Report on Objections to Part 10 Development (ACP-323950-25)

Graiguenamanagh Tinnahinch Flood Relief Scheme

Report No. W3451-W-R021

Kilkenny County Council

Figure 1-1. Inlet conditions on Vortex Flow Control Structure on a UK EA flood scheme (typical low flow conditions).

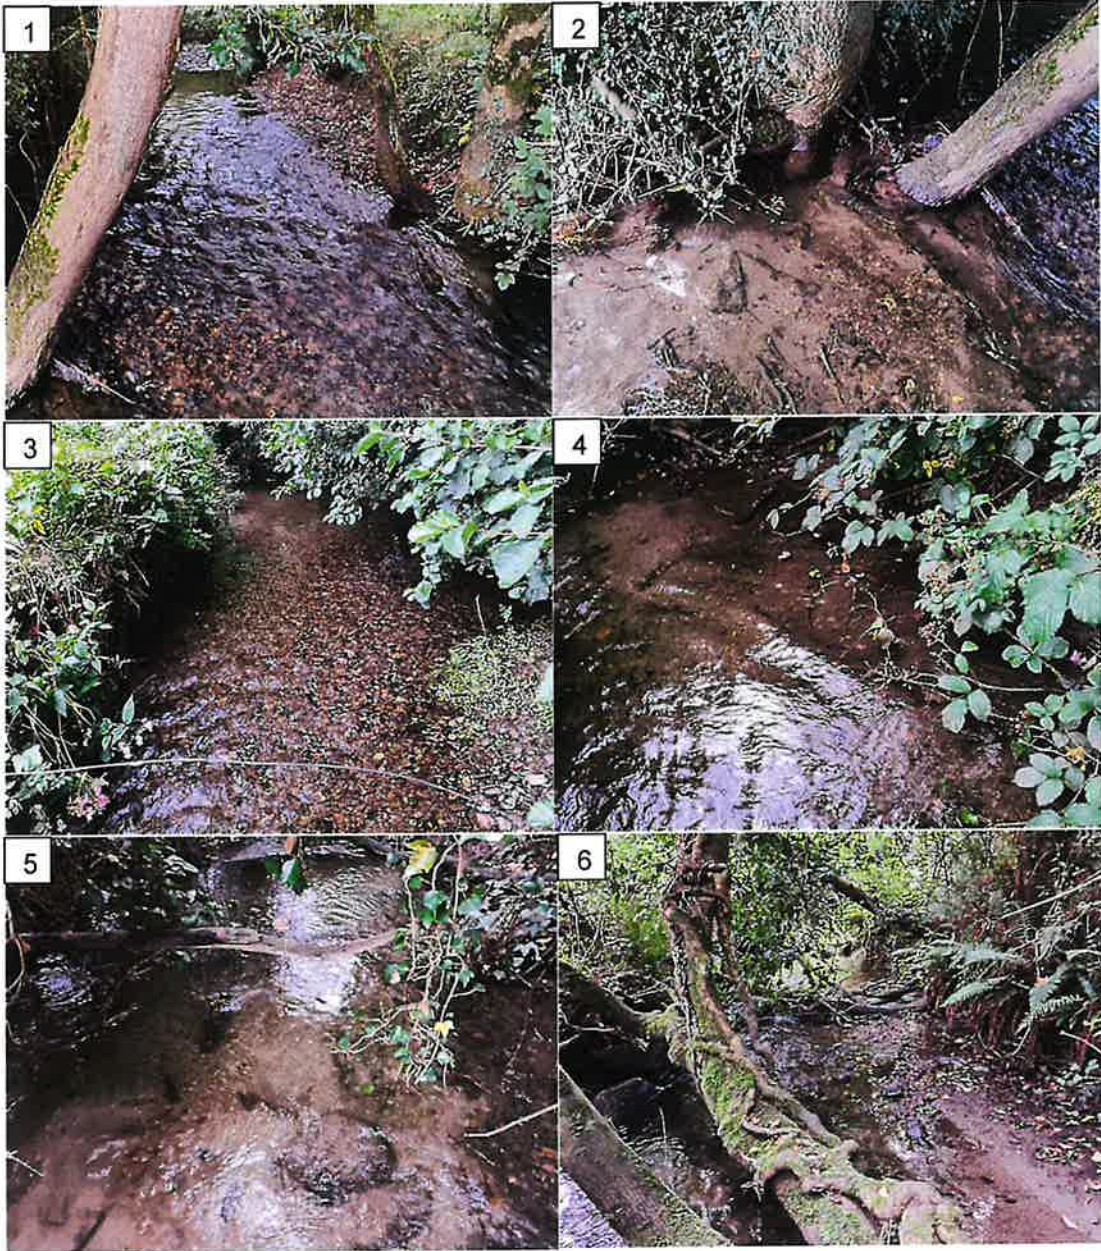
The flow control structure will not prevent the migration to upstream spawning grounds. During typical flows, the flow velocities are similar to the prevailing conditions as outlined in Figure 1-1. Inlet conditions on Vortex Flow Control Structure on a UK EA flood scheme (typical low flow conditions). Figure 1-1 and Figure 1-2 below. The project team for GTFRS visited sites in the UK to observe hydrobrake (vortex control structures) 1st hand and are satisfied that upstream and downstream migration of both fish and small waterborne mammals will be possible. The use of vortex control for such purposes is well documented¹.

Figure 5-1. EPA Hydrotool Estimates of Annual percentile exceedance flows (<https://gis.epa.ie/EPAMaps/Water>)

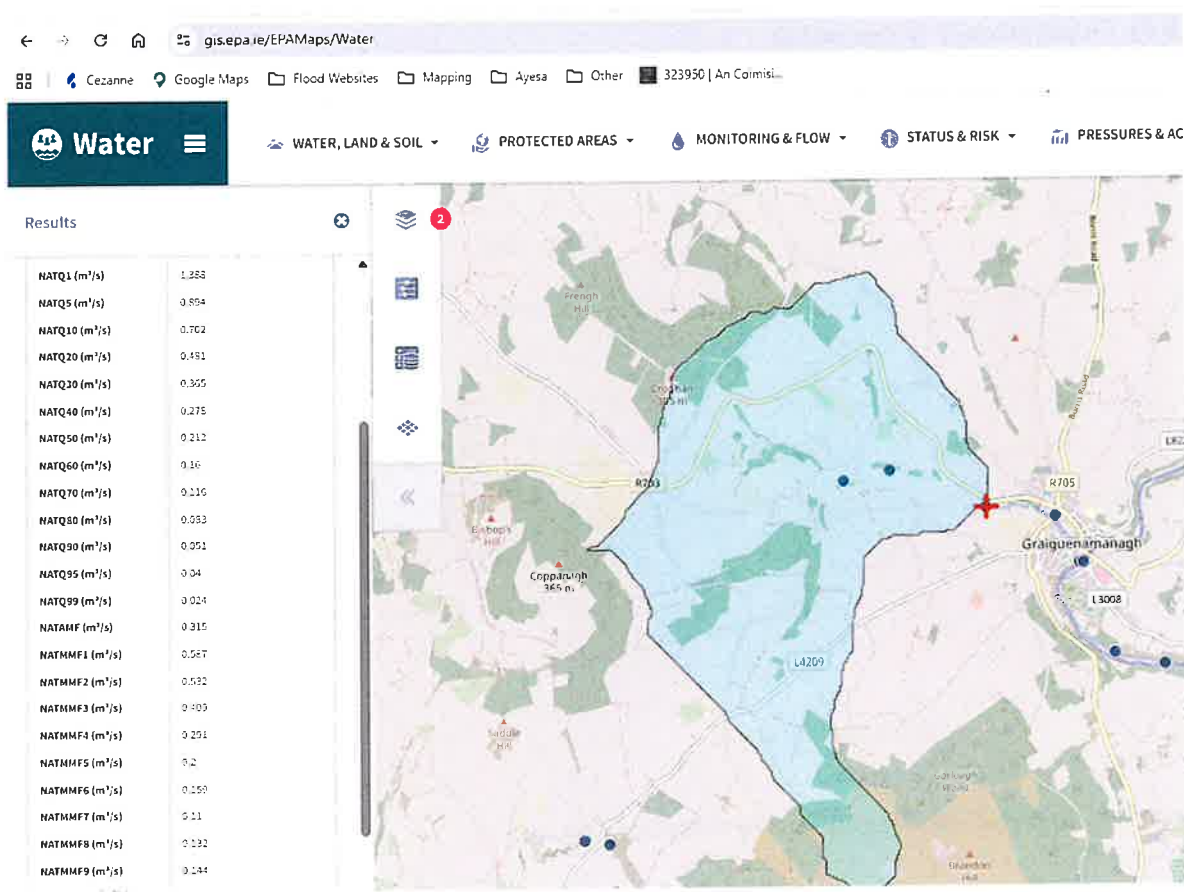
Fish migration will not be impeded to the upstream of the flow control structure. During flood events, passage may not be possible, but such event is short lived and fish migration is generally limited to much smaller flows. Fish migration is typically reviewed against annual percentile exceedance flows (flow duration curves).

The EPA River Flow Estimate Hydrotool estimates the 1% annual percentile exceedance flow in the River Duiske at Priests Valley to be 1.388m³/s. This is the flow that is statistical expected to be beaten just 1% of the time in an annual event. The hydrobrake permits 3m³/s to pass forward at all times, only storing flows for larger (extreme), multi-annual events, such as the design standard 1% AEP event.

As such, the storage area will have no impact on flow rates that affect fish migration in the river Duiske.

Figure 5-2. Estimated Inflow Versus Outflow of Storage Area

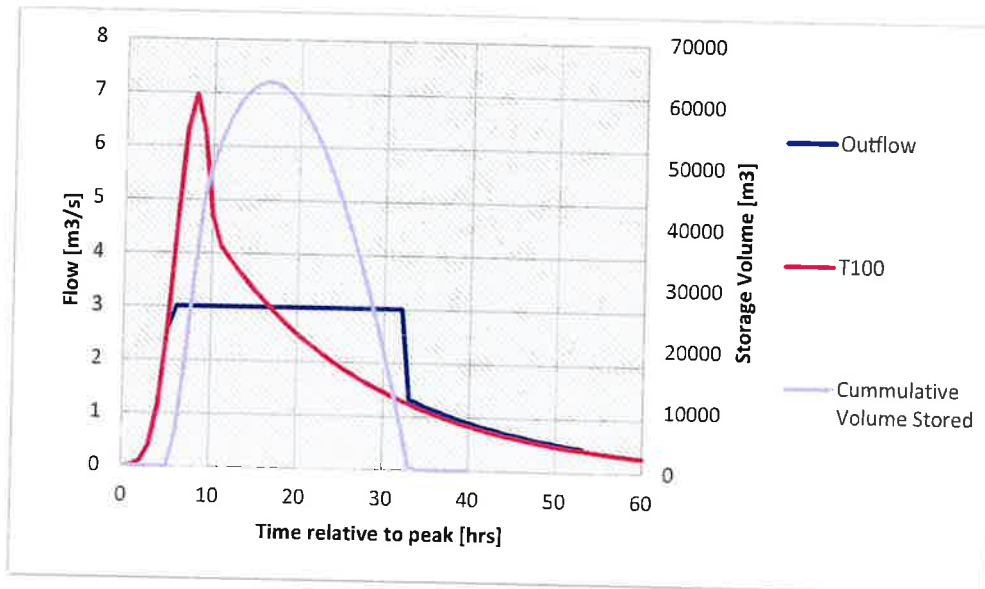
The time taken to fill the storage area is expected to be circa 16 hours for the design event. The emptying time is circa 18 hours. The total duration is circa 34 hours, depending on flood retention period.

The storage area has a 1% chance in any given year of being used to the design standard. Flooding can occur at any time and is not more likely in winter. Typical river velocities will not be impacted. During large magnitude flood events, instream velocities downstream of the storage area will marginally reduce, whilst velocities upstream of the storage areas will also reduce. The reduced in-stream velocities may prevent excessive disturbance to eggs and alevins.

Figure 6-2: Extract of Graiguenamanagh/Tinnahinch Joint Local Area Plan 2021 Map1

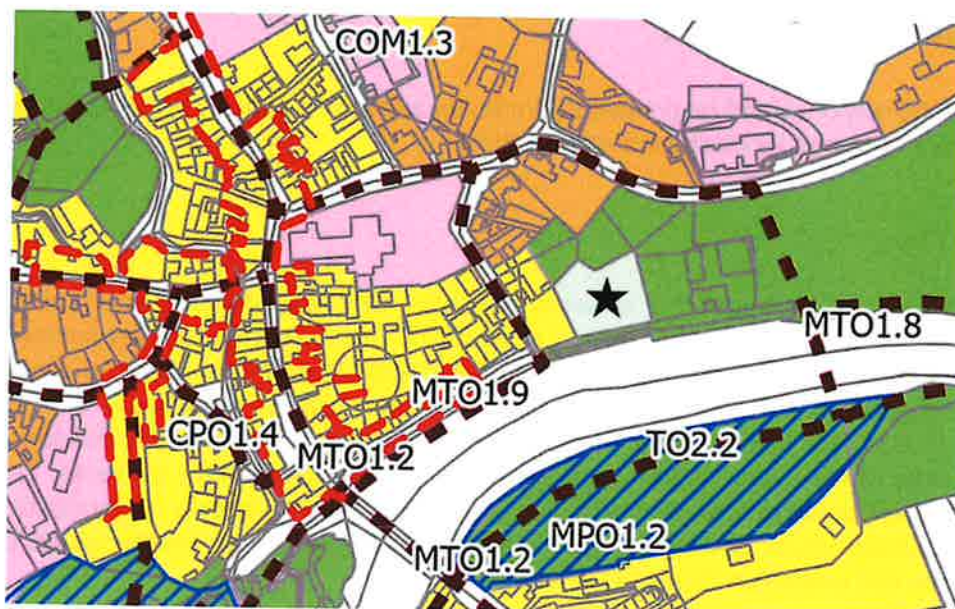
Plot 19 has a designated ‘Mixed Use Zoning’. However, the site is also at risk of flooding for the 1% AEP event. In-fact, flooding of the site begins for the 20% AEP event (1in 5 year) and as such, the flood risk to the site is quite severe.

The proposed flood scheme, whilst reducing the developable area of the site will not sterilise the remainder from future development. It will in fact, assist any proposer in addressing the flood risk management issues associated with the site.

Figure 7-2: W3451-AYE-DWG-W-1404-02 from Appendix 4-1 of the EIAR

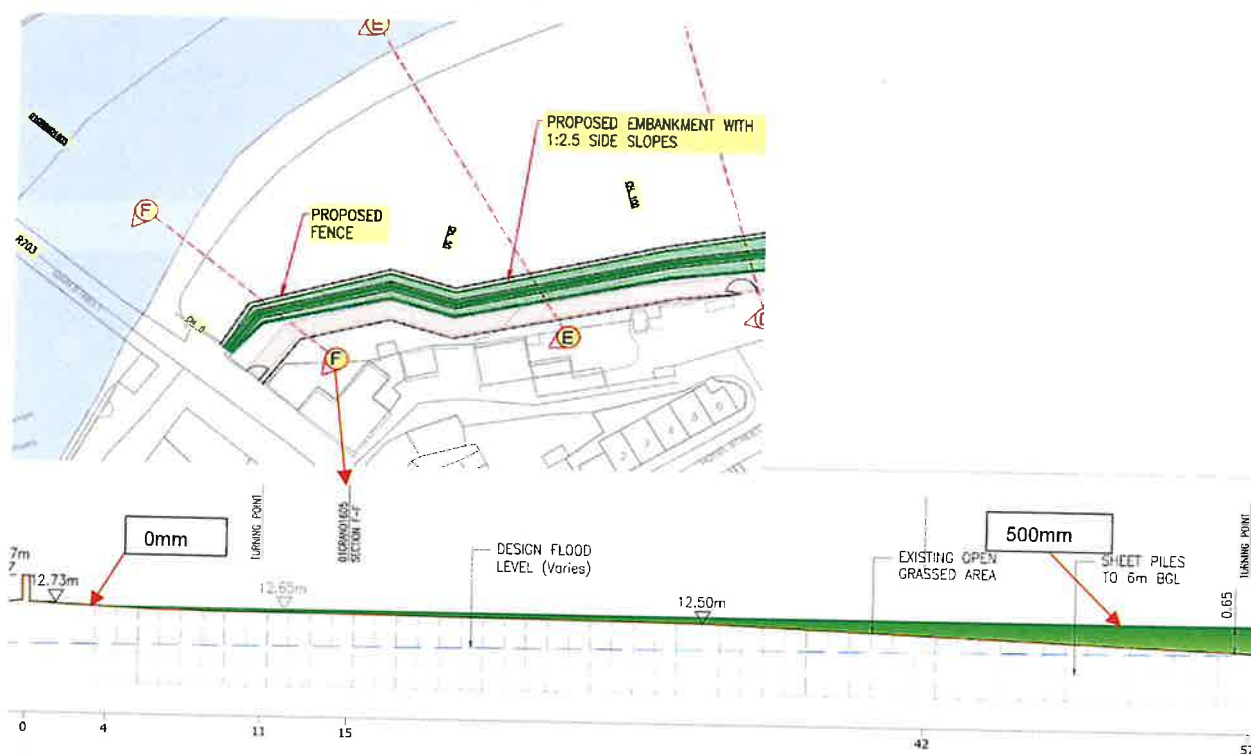
The proposed flood measures adjacent to the rear patio and garden of the subject property are quite low. At this particular point, and as the Walsh's have identified elsewhere, the 1% AEP flood level does not actually reach the location of the embankment. The embankment has been aligned to reach ground with sufficient freeboard to address the inherent and unavoidable uncertainties of flood level estimation. The freeboard for the scheme is 550mm and given the ground is slightly higher than the flood level, this means that the embankment ranges from 0m high to 500mm high in the vicinity of the Walsh's.

Whilst it is acknowledged that the views will be impacted, the scale of the impact is considered to be very limited impact on views from the property and patio.

Figure 7-4: Extract from Figure 11-13 of the Hydraulics Report comparing current (blue line) and proposed flood extent (hatched blue) at Walsh’s property.

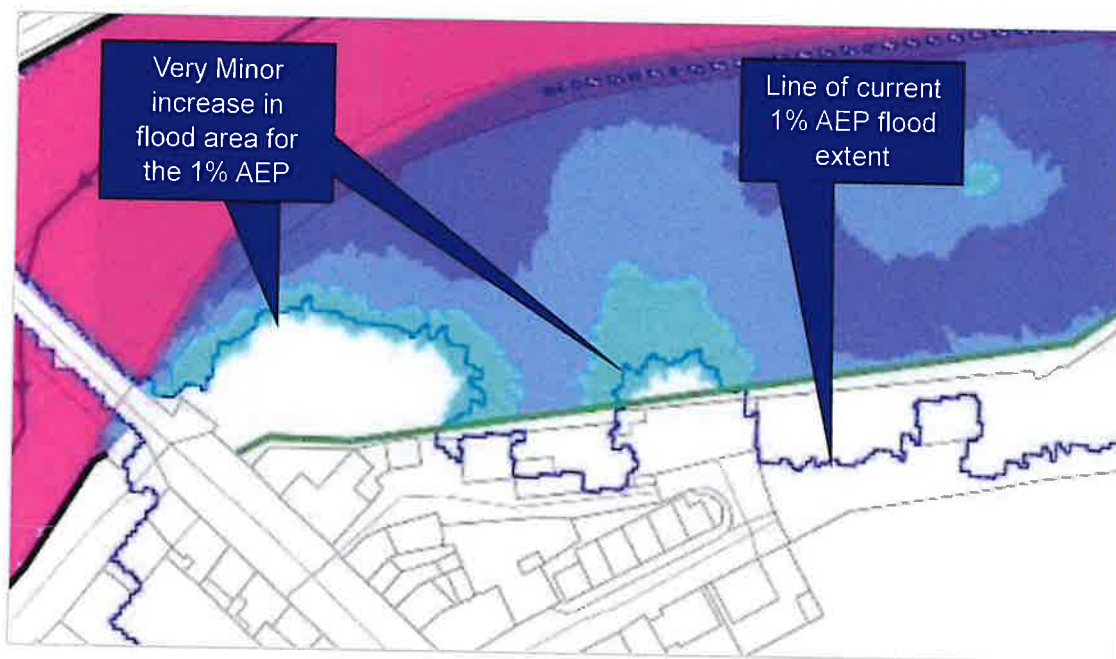
The proposed lands form part of the natural floodplain of the River Barrow and are already at risk of flooding. Any additional increase in the frequency of flooding, driven by the proposed solution is at the very minor scale. This was considered in the Hydraulics Report for the scheme² as shown in Figure 7-4: Extract from Figure 11-13 of the Hydraulics Report comparing current (blue line) and proposed flood extent (hatched blue) at Walsh's property.

Whilst Figure 7-4 outlines the 1% AEP flood extent, it is not correct to say that the lands beyond this extension are not floodplain. They lie within the 0.1% AEP event extent, or Flood Zone B in planning terminology.

In summary, the impact of the scheme to the lands is minimal, with most of the lands currently at risk of flooding.

Figure 7-5: Extract from Engineering Drawings W3451-DWG-W-1404 illustrating accessways

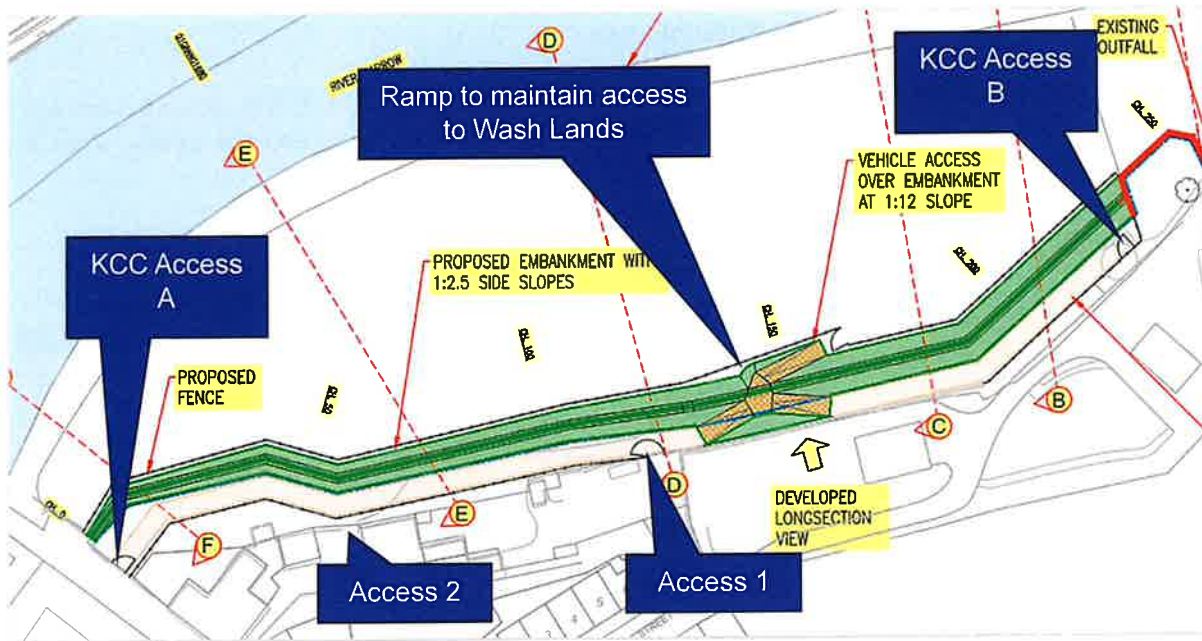
KCC are aware of two main access routes for vehicles/machinery to the lands, both through other lands within the Walsh ownership. It is not proposed to affect these accesses, and provision has been made for access over the embankment at the eastern most access (Access 2) as per the planning drawings. This is for the Walsh’s benefit. KCC are open to sharing Access A also if the landowners desires. Figure 7.5 **Error! Reference source not found.** below outlines the layout plan whilst Figure 7.6 shows the current arrangements.

Any injurious effects identified will be assessed and compensated under the CPO process. Garden patio and outdoor area are to be retained in the ownership of the occupants of the house.
